**BEFORE THE PUBLIC UTILITY COMMISSION**

Docket No. LC 77

2021 Integrated Resource Plan.

Staff Opening Comments

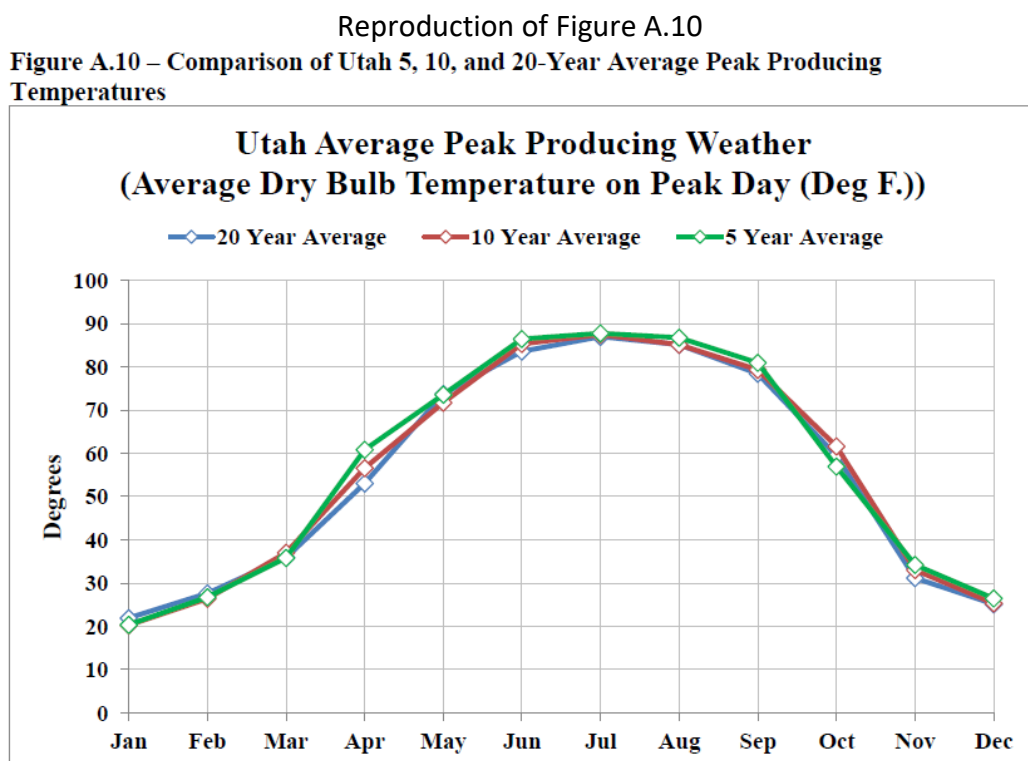
Figure A.10 shows that 5-year average temperatures are slightly higher than 10-year averages, which tend to be slightly higher than 20-year averages. This is indicative of a warming trend. Staff appreciates PacifiCorp consideration of this matter, and accepts that moving to a 5- or 10-year average for the base case load forecast does not seem likely to have a significant impact in this IRP. However, Staff would appreciate continued consideration of whether 5- or 10-year averages will be necessary to inform an accurate load forecast in future IRPs.

**Figure A.11 – Load Forecast Scenarios for 1-in-20 Weather, Climate Change, High, Base Case and Low, pre-DSM**

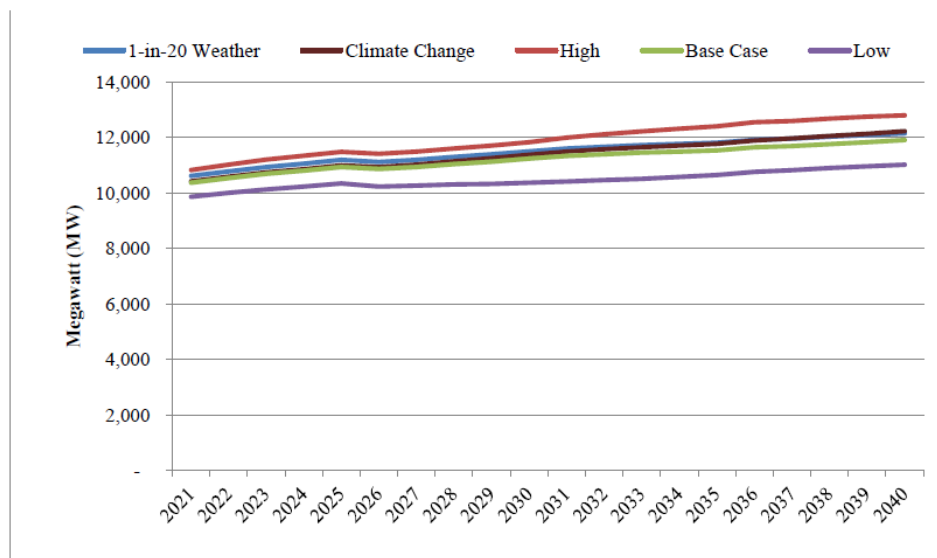
Staff appreciates the climate change scenarios considered in the 2021 IRP and finds the analysis to be somewhat useful for considering how many additional MW of capacity may be needed to reliably serve load under a variety of future climate scenarios. However, the 2021 IRP does not show what resource portfolio would be needed to meet the climate change load forecast using reference planning assumptions. The climate change scenario in the 2021 IRP utilizes the Social Cost of Carbon instead of MM reference case assumptions, and as such it cannot isolate the effects of the climate change load forecast. In future IRPs, it may be informative to include a climate change scenario that uses reference case (MM) IRP assumptions to demonstrate the resource decisions the Company would make if it incorporated climate change forecasts into its reference case planning.

Figure 6.4 from the 2021 IRP is shown here for reference:

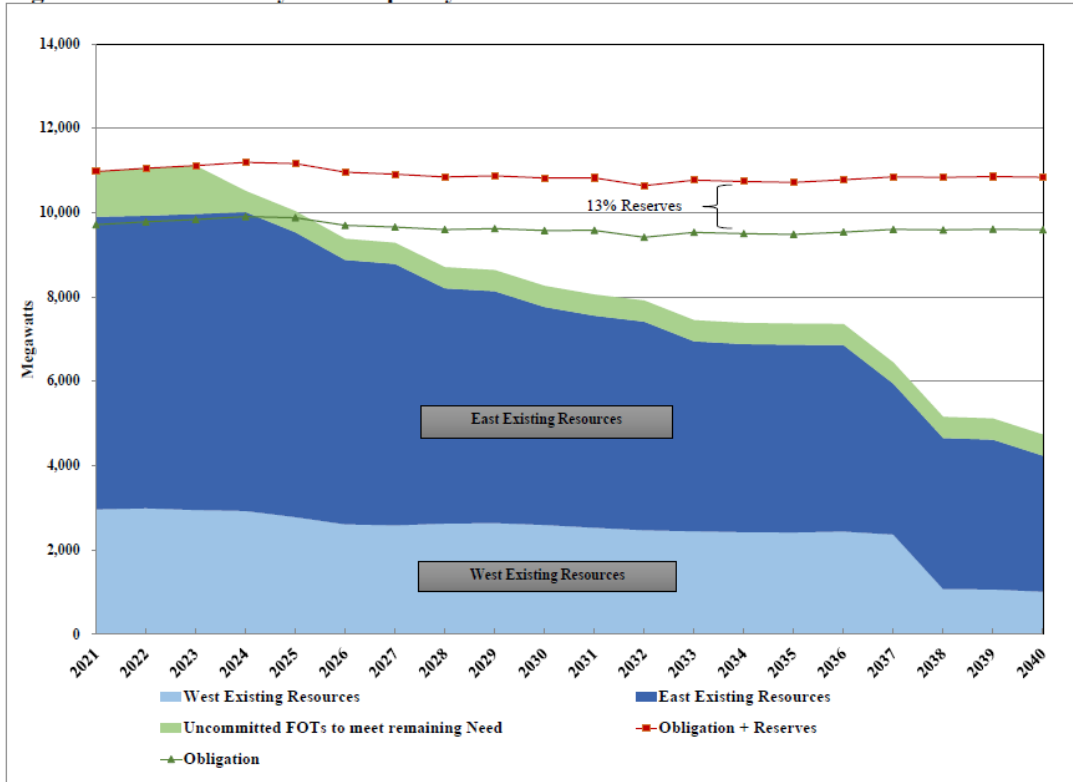
Staff highlights that available front office transactions are forecasted to decrease sharply in 2024, the same year as PAC’s first capacity need.

Below is a reproduction of PAC Figure 6.2 which shows QF contract capacity falling with contract expirations:

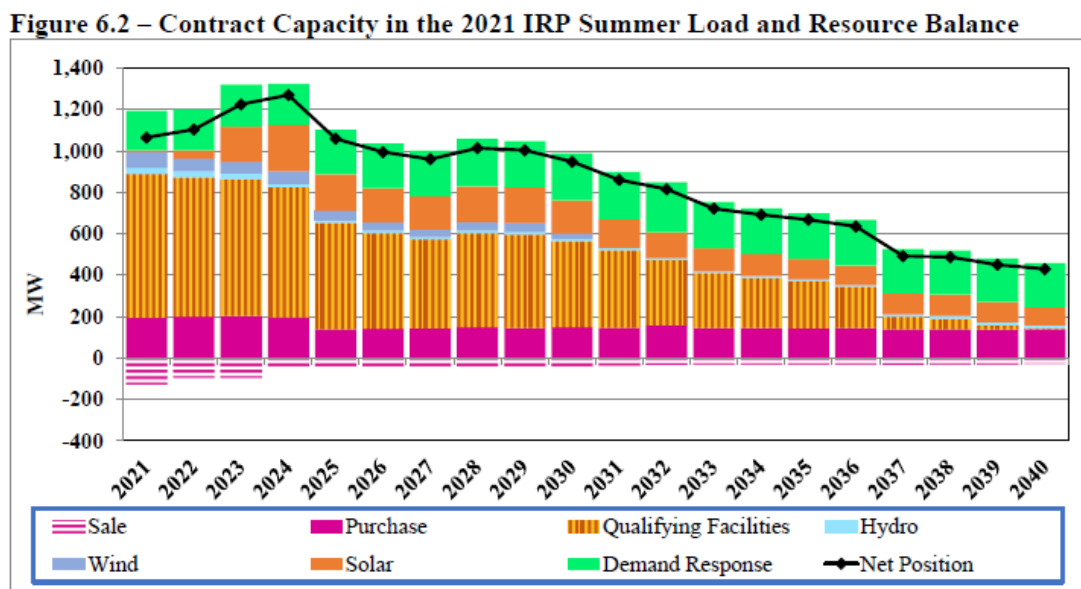
Unfortunately, it is not clear to Staff how the Company has “explained the impact of renewing QFs on its load resource balance” in the 2021 IRP. It appears that the QF contract renewal assumptions are unchanged from the 2019 IRP and no study has been done to show the potential effects that QF renewals might have on capacity. While the IRP states that the impact of QF renewal assumptions is explained in Chapter 6, Staff is unable to locate any analysis of QF renewal assumptions in that chapter.<sup>64</sup>

**Staff recommends that PacifiCorp also begin to include a non-zero rate of QF renewals in its long-term forecast, or as a sensitivity. To address near-term reliability concerns, a zero-renewal rate could be used in the near-term Action Plan timeframe, while a reasonable renewal rate could be assumed thereafter.**

Reproduction of 2021 IRP Figure 9.37:

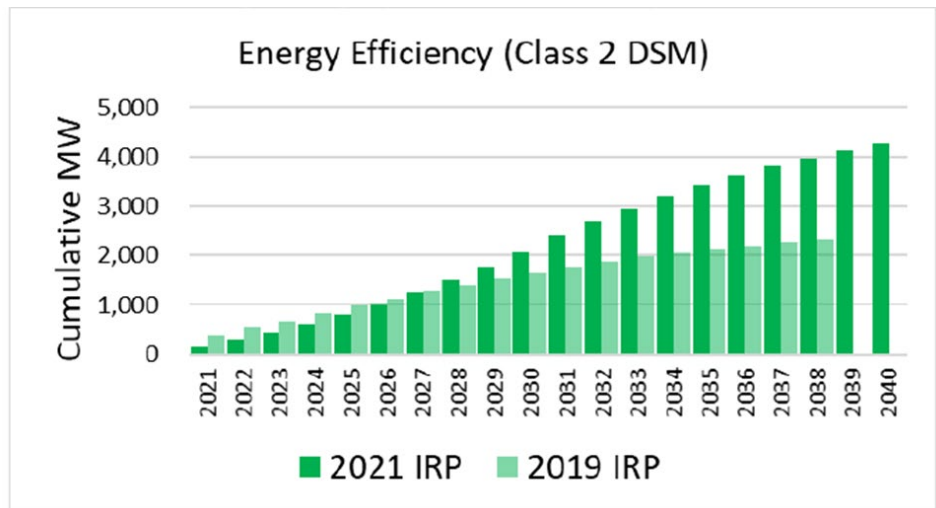
The Company's preferred portfolio includes 4,290 MW of energy efficiency over the planning period, which is significantly more energy efficiency than the previous IRP, particularly in the later years.

**Figure 1.1 First Year Energy Efficiency Resource Selection for Preferred Portfolio**

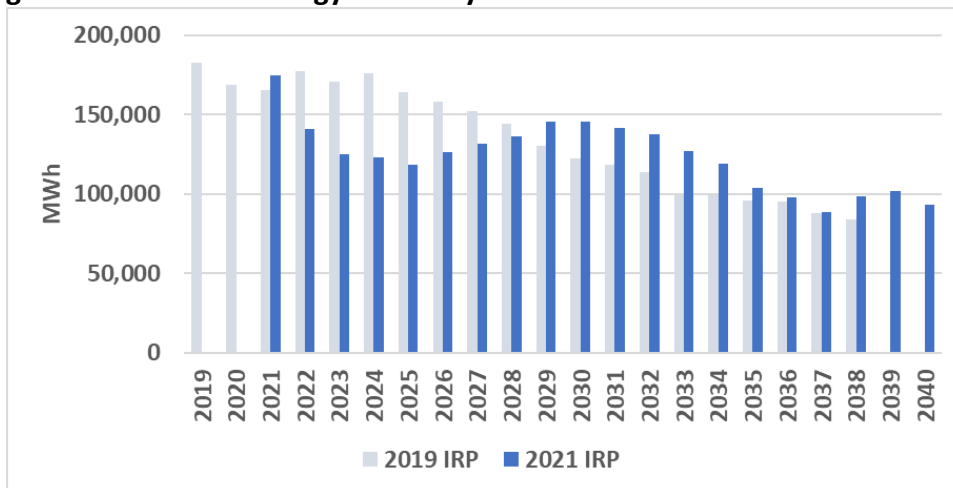
Staff compared the energy efficiency selection between IRPs for Oregon specifically, looking at the energy from the first year selected. Staff found that while the system selection of energy efficiency is higher, the selections for Oregon are lower in the current IRP, particularly in the earlier years.

efficiency. Energy Trust expects cost-effective energy efficiency acquisitions to increase in 2022 and 2023.<sup>72</sup> This suggests that the model is not selecting all cost-effective energy efficiency and these selections should be modified to reflect near-term program activities in Oregon.

In Reply Comments, Staff requests that the Company provide an explanation of how these results will inform energy efficiency acquisition in Oregon. Staff is particularly interested in any modifications the Company intends to make to be consistent with available cost-effective energy efficiency in Oregon.
